IREDELL COUNTY HEALTH DEPARTMENT

IMPROVEMENT PERMIT / AUTHORIZATION TO CONSTRUCT / OPERATION PERMIT / EXISTING SYSTEM INSPECTION

PERMIT# 135868 PIN# ~~4730-36-1597~~ 4730-36-7597 DATE 8-8-06

Street Address	Subdivision Name	Section/Phase and Lot Number
119 LOT #3 RUSHING WATER	TWIN CREEKS	L-3

Twin Creek Lot 3

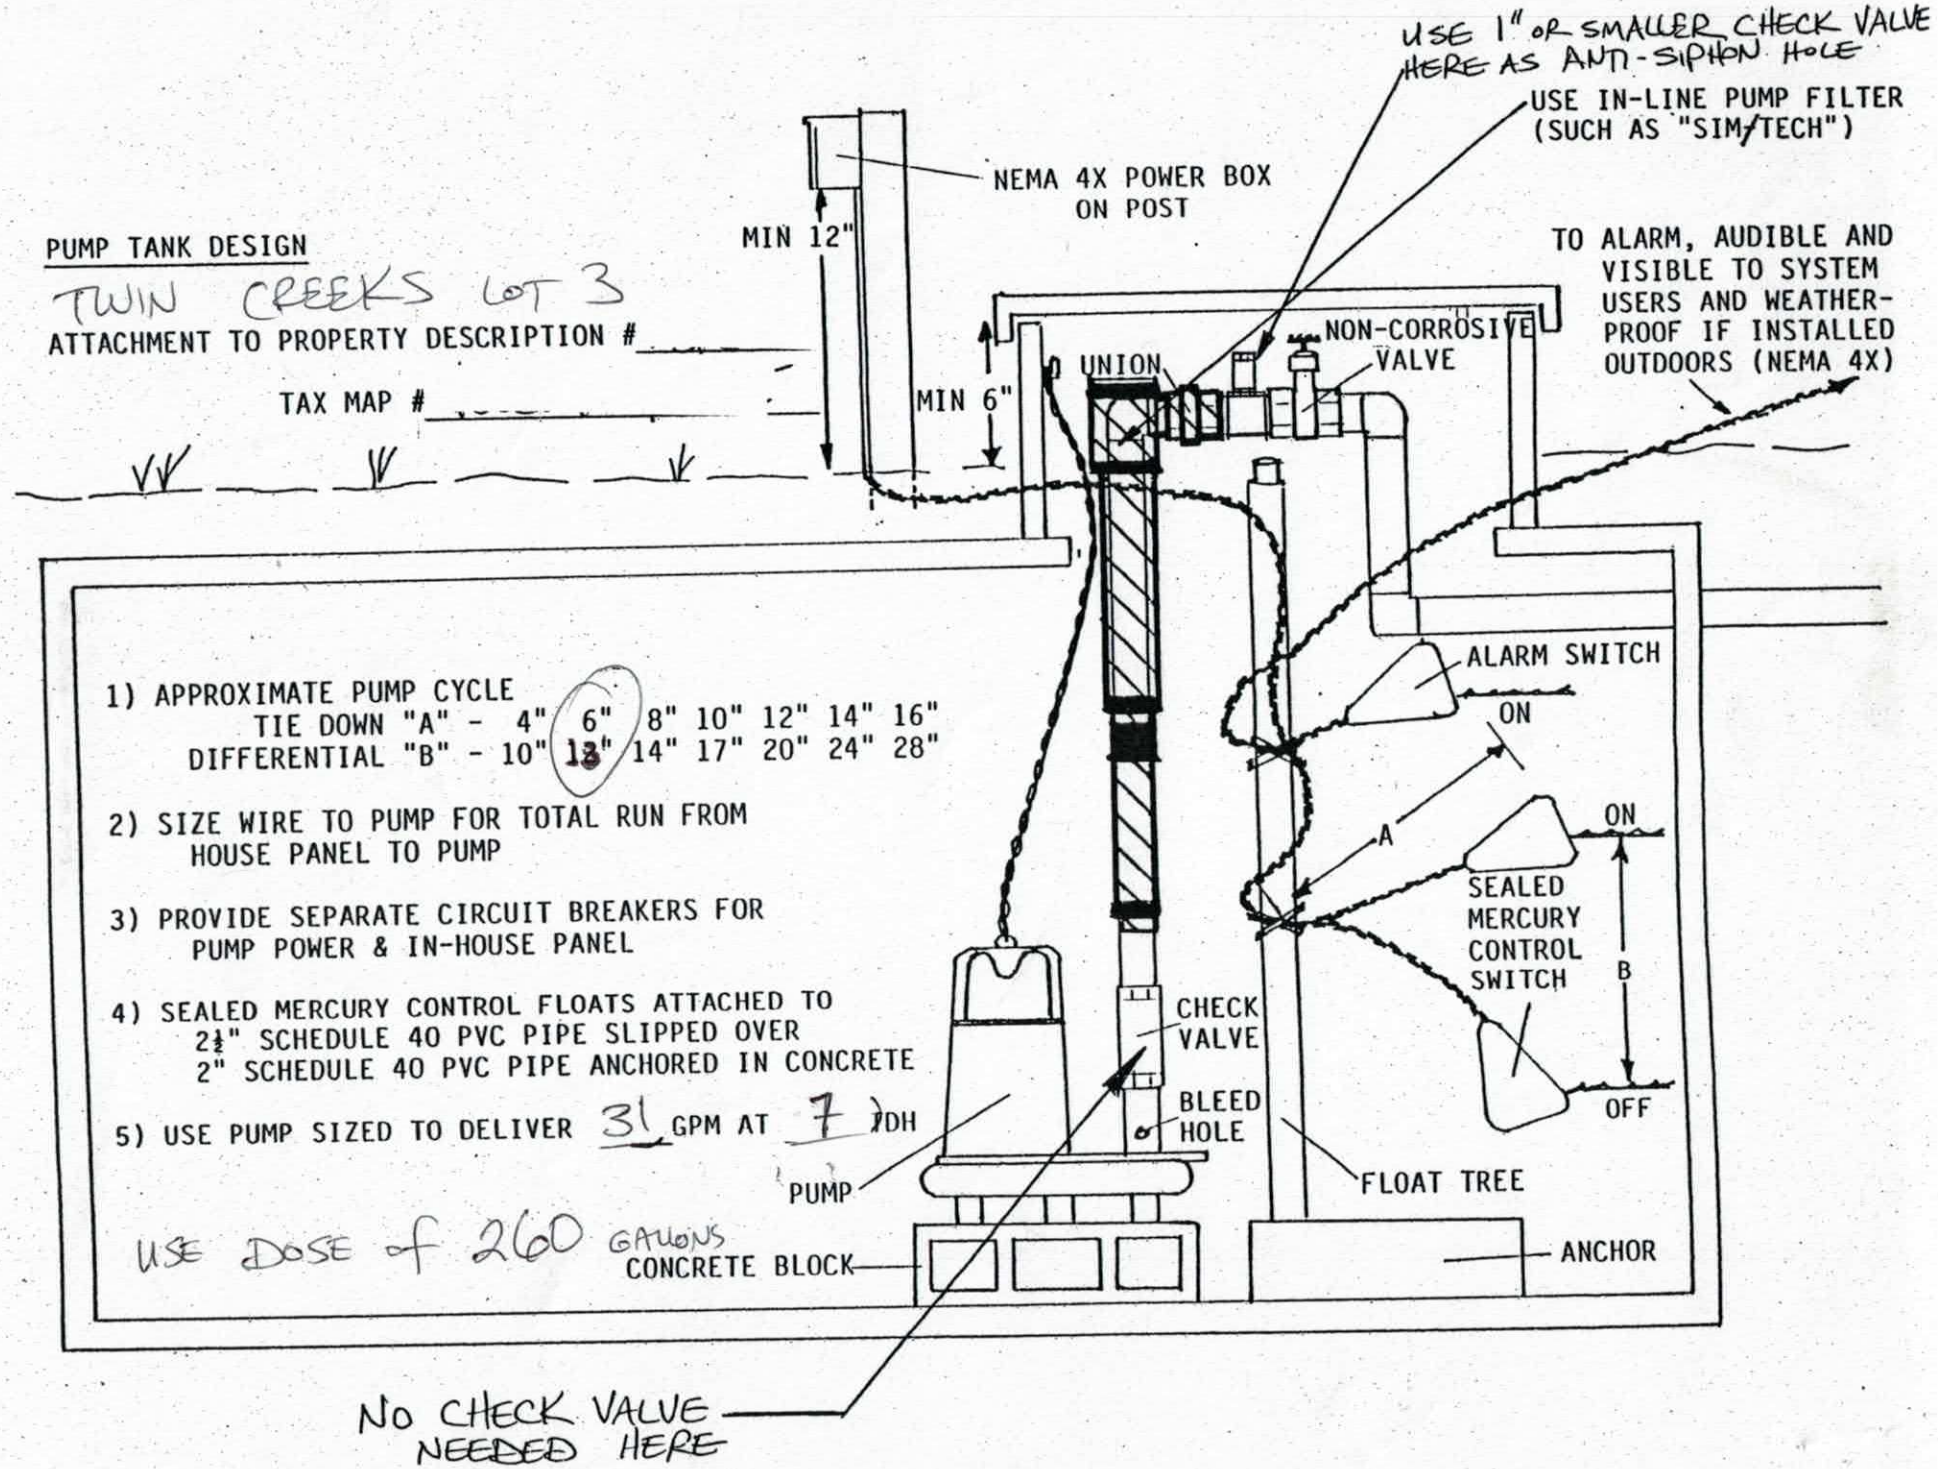
@ 54' each
* Pump worksheet - Check valve as anti siphon rule.

USE 1" OR SMALLER CHECK VALVE HERE AS ANTI-SIPHON HOLE
USE IN-LINE PUMP FILTER (SUCH AS "SIM/TECH")
NEMA 4X POWER BOX ON POST
MIN 12"
MIN 6"
TO ALARM, AUDIBLE AND VISIBLE TO SYSTEM USERS AND WEATHER-PROOF IF INSTALLED OUTDOORS (NEMA 4X)
UNION
NON-CORROSIVE VALVE
PUMP TANK DESIGN
TWIN CREEKS LOT 3
ATTACHMENT TO PROPERTY DESCRIPTION #
TAX MAP #

SECOND FLOOR PLAN

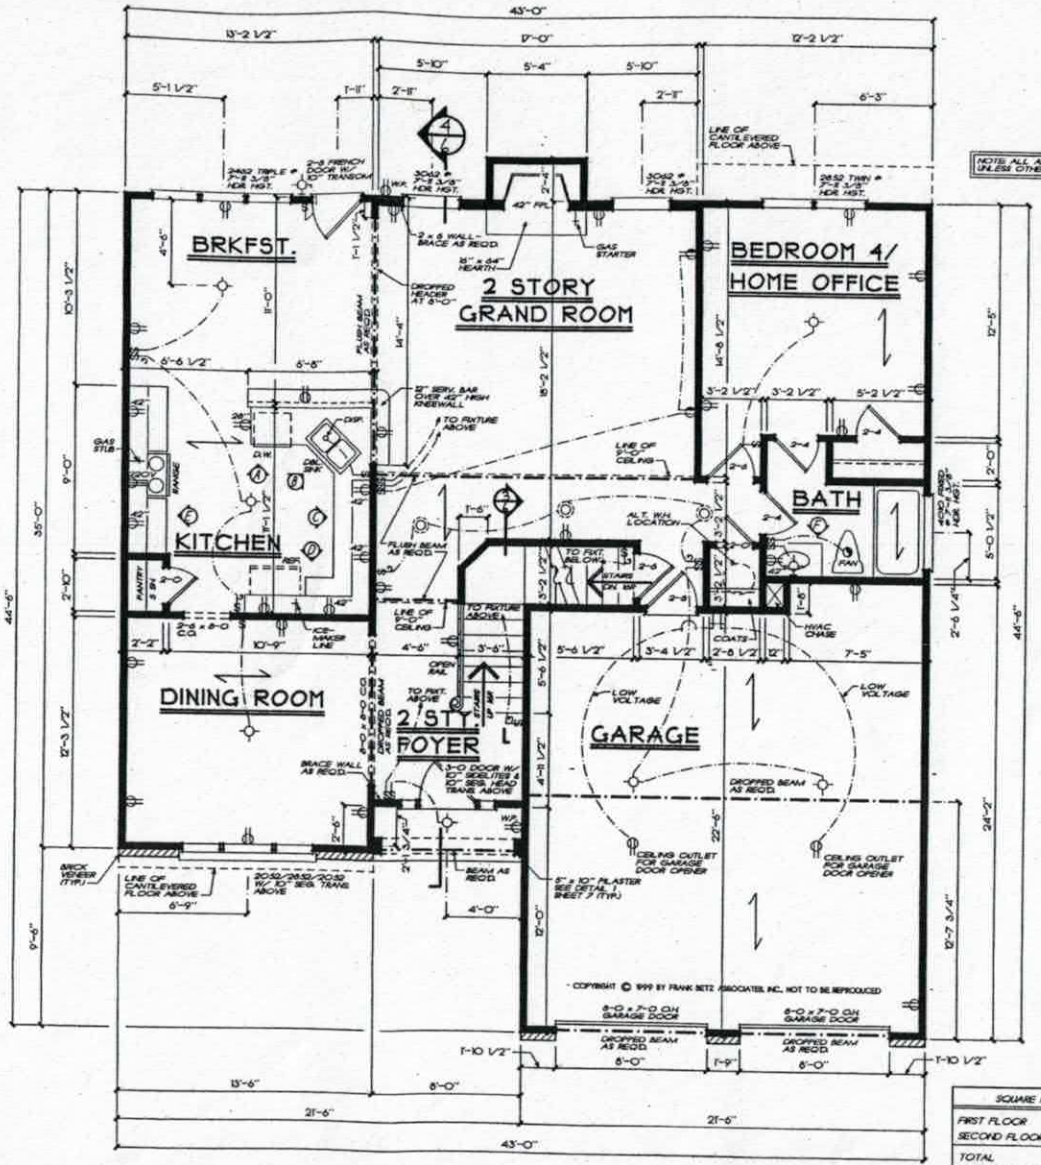
MAKE THIS A CASED OPENING PER INSPECTOR'S ON 8-14-07

COLONNADE - Upper Floor

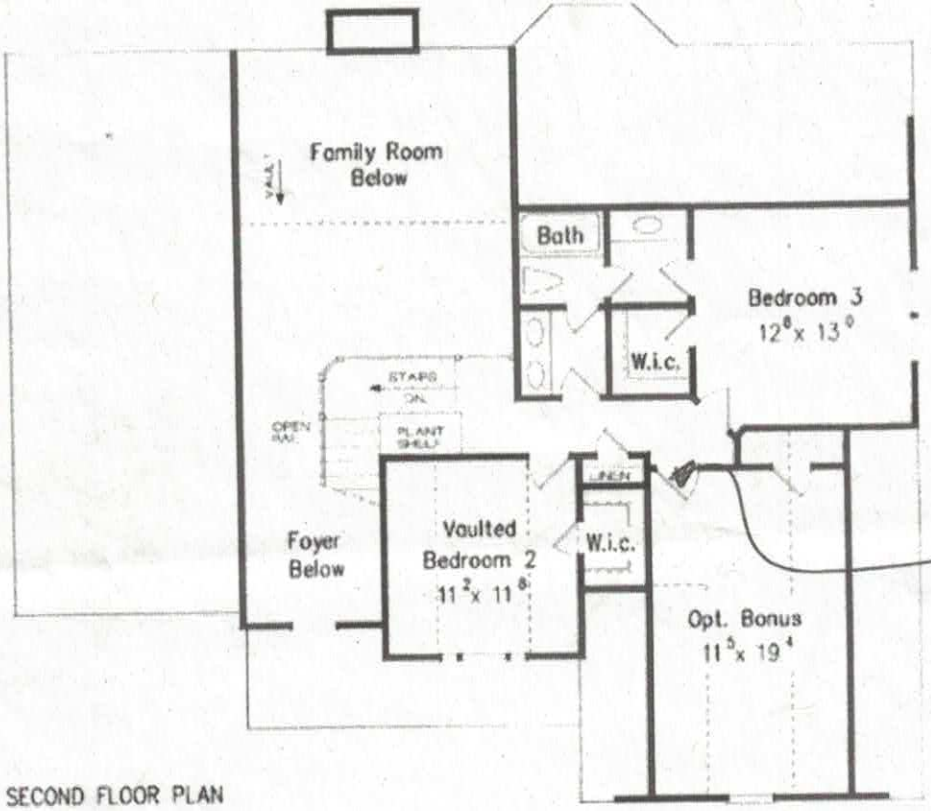
CASED OPENING
NO DOOR
Ulla Brown
6/14/06
